NUREG/CR-1925
SAND81-0242

Diablo Canyon Nuclear Power Station Unit 1 Auxiliary Feedwater System Reliability Study Evaluation

The purpose of this report is to present the results of the review of the Reliability Analysis of the Diablo Canyon Auxiliary Feedwater System. The analysis was prepared for Pacific Gas and Electric Company, the licensee for Diablo Canyon, by Pickard, Lowe and Garrick, Inc.

FIGURE 2. RELIABILITY CHARACTERIZATIONS FOR APWS DESIGNS IN PLANTS USING THE WESTINGHOUSE NSSS

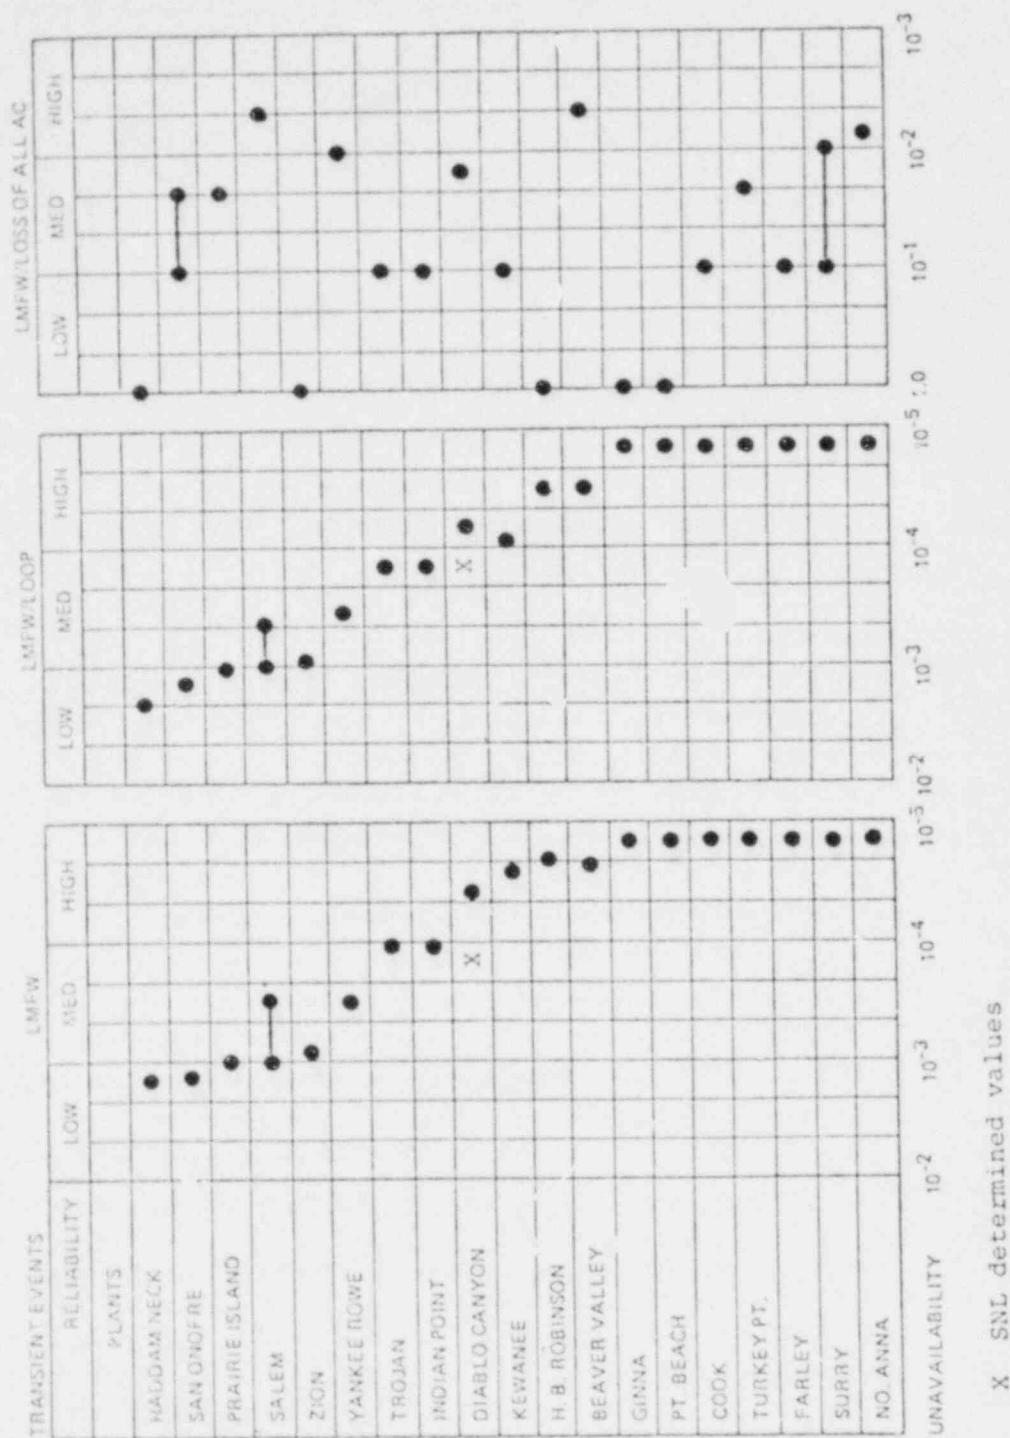
failure in the event of no NPSH has not been established. The operator action should not be considered and the unavailability increased to 1×10^{-4} , the value assigned to the CST outlet valve 1-671 being closed. This value is combined with the unavailability of the other cutsets of lesser rank and plotted on Figure 2. All other values seem appropriate.

The final assessment made by PG&E places Diablo Canyon at the high end of the range of reliability reported in NUREG-0611 for operating Westinghouse plants. Sandia is not in agreement with this assessment for Case 1 and 2 because of questionable recovery factors used to lower the failure assessment of critical basic events. Sandia concludes that for Case 1 and 2 the reliability should be in the medium range.
